**Final
Environmental Impact Report
for the
Ventura County Medical Center Expansion**

SCH # 93041042

Ventura County Public Works Agency

FUGRO-McCLELLAND (WEST), INC.
2140 Eastman Avenue / Ventura, California 93003

**EXISTING
VCMC FACILITIES**

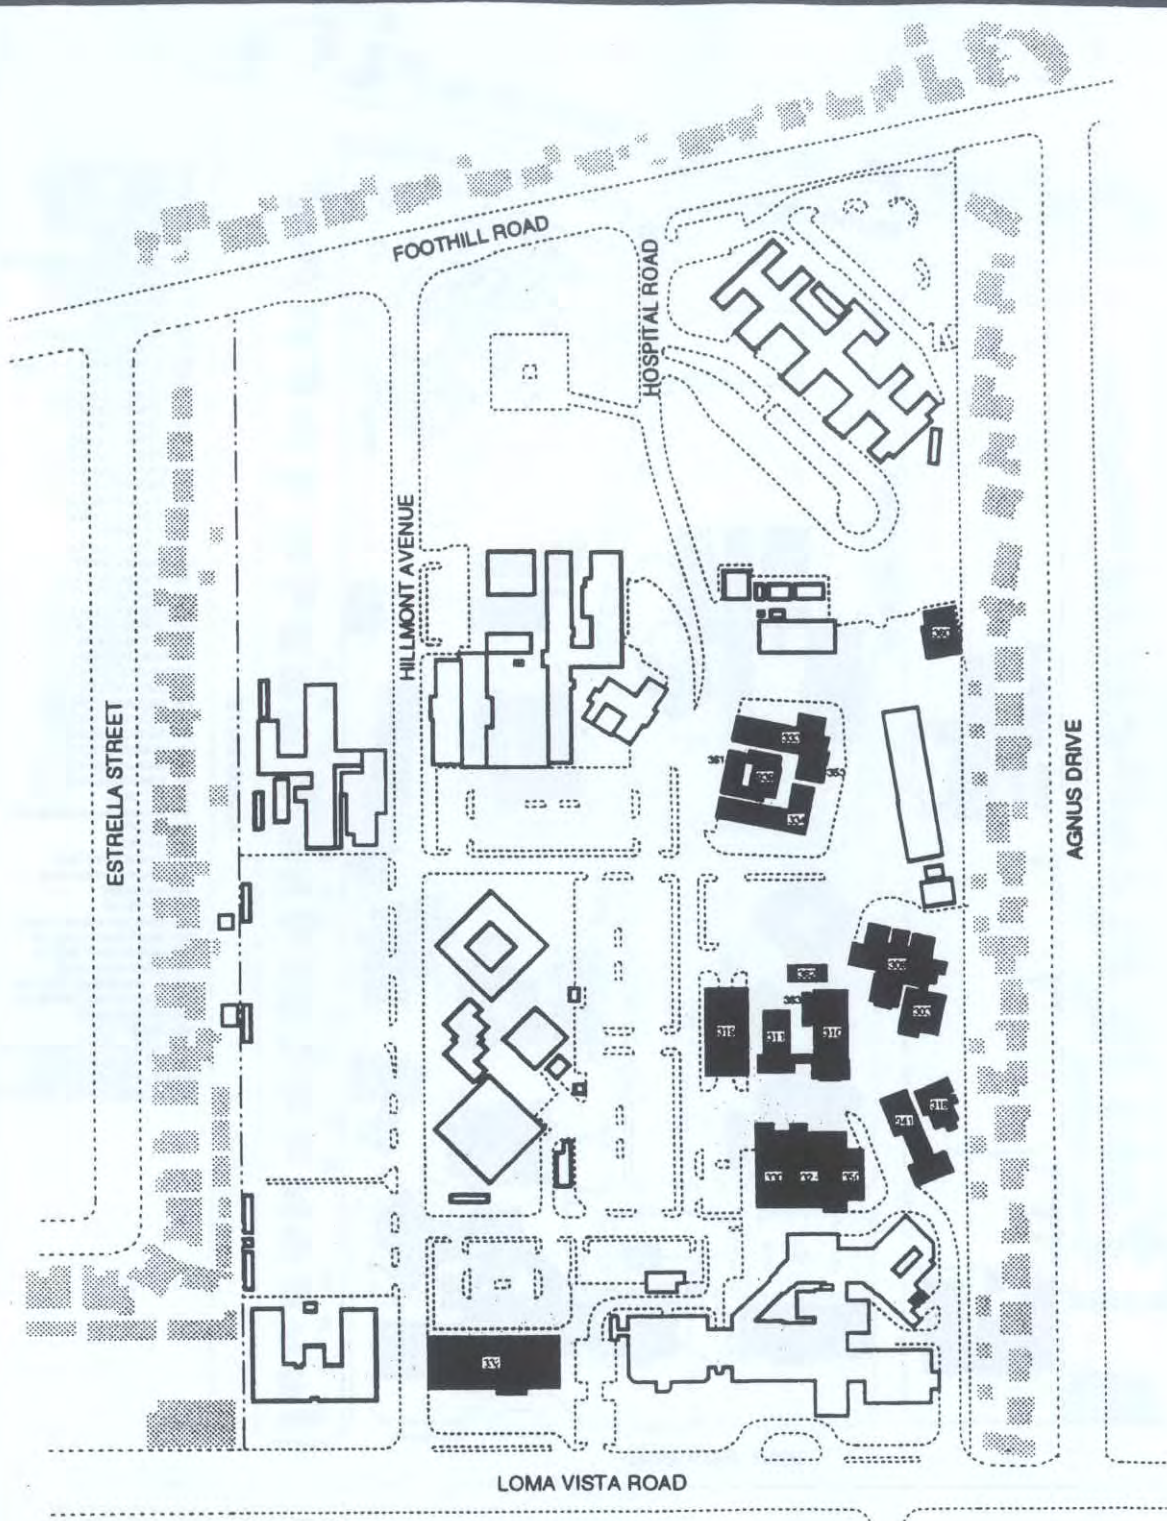
3. Page 3-4, Section 3.4 PROPOSED ACTIONS - Second paragraph does not appear to list all the buildings to be removed from the site. | C
4. Page 3-5 and 3.5, Figure 3.3-1 or 3.4-1 - Where is PSSA building? | D

5.D The former PSSA Building, now known as the HCA Business Office, is Building 332 as illustrated on Figure 3.3-1. The building is located at the northeast corner of the Loma Vista Road/Hillmont Avenue intersection. The building would be demolished prior to construction of the new Mental Health In-Patient Unit.

FIGURE 5.3-2

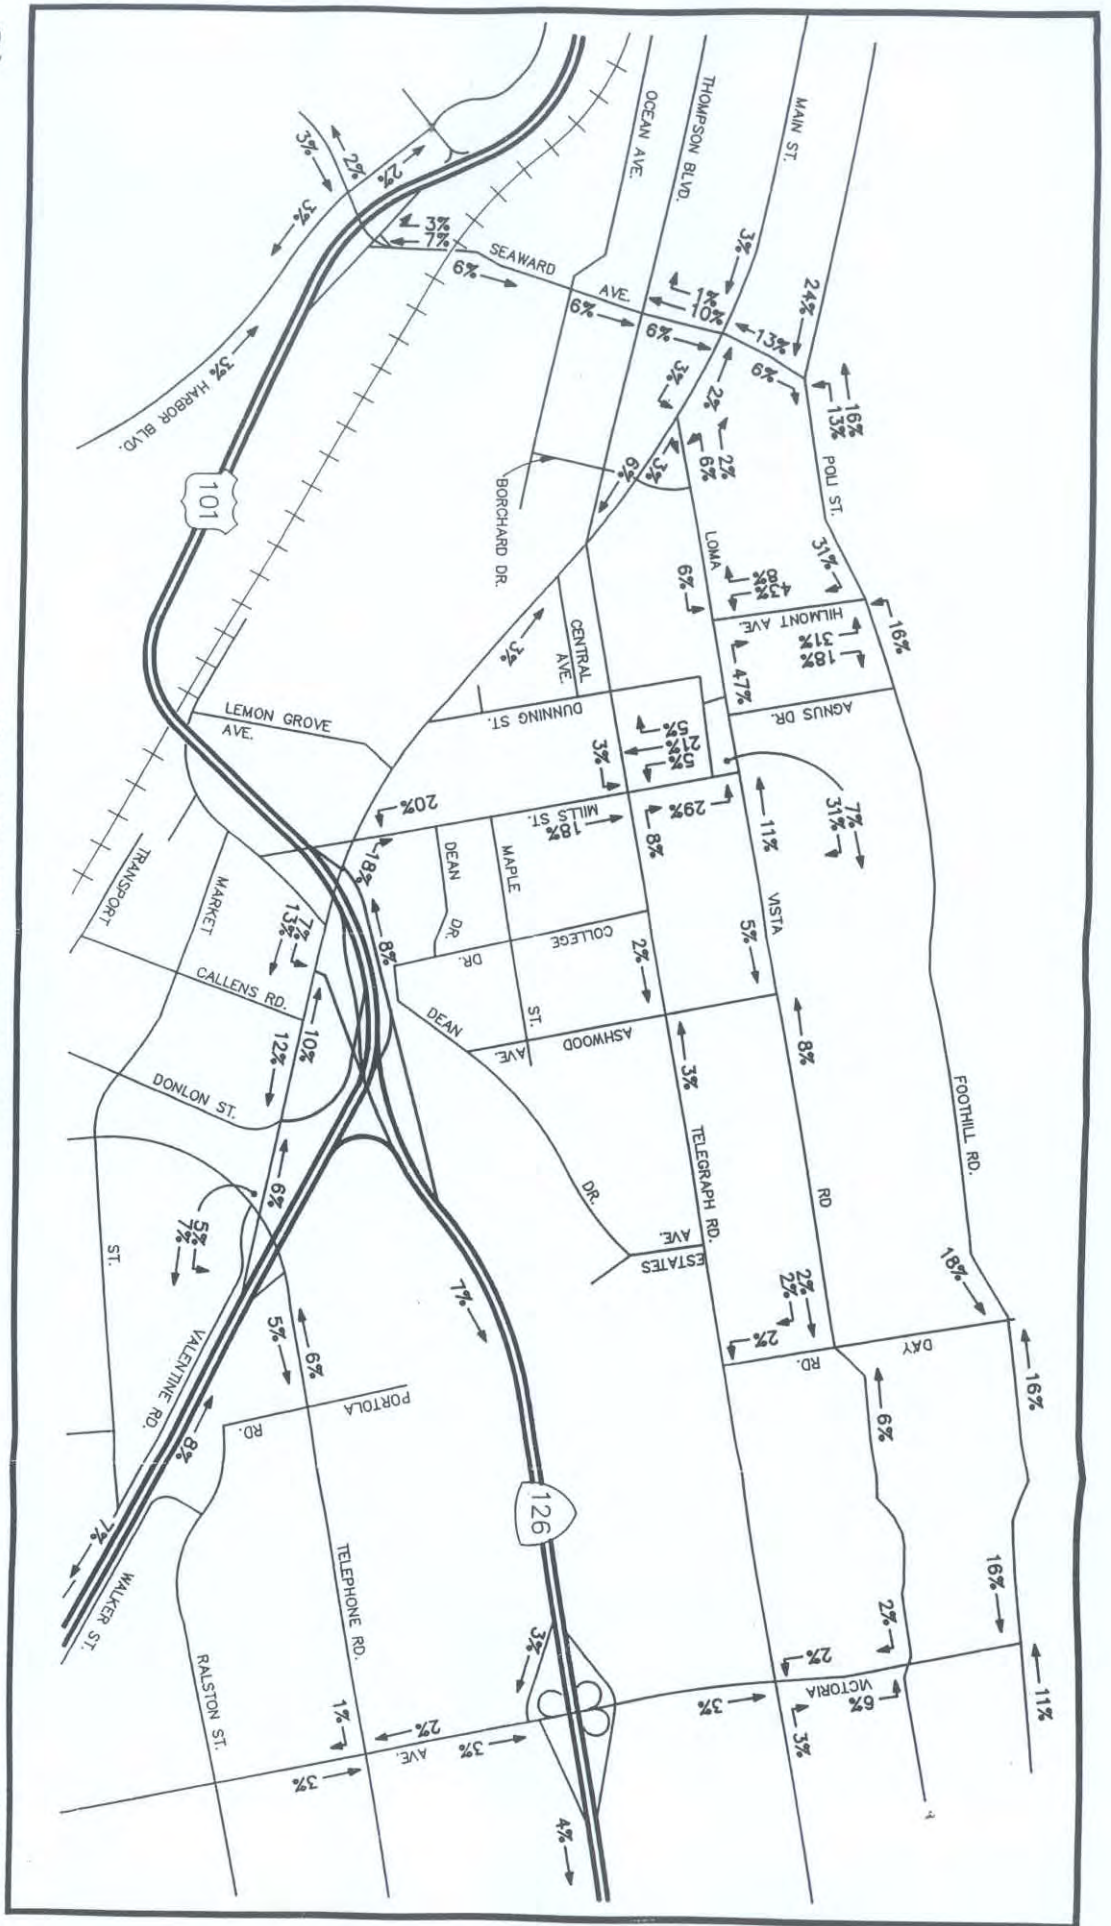
In response to your request for review of the Draft Environmental Impact Report (DEIR) for the subject project, Page 5.3-8 and 5.3-11 (Figure 5.3-2) correctly identifies that there are no significant environmental impacts to level of service on County roads or the Regional Road Network. A
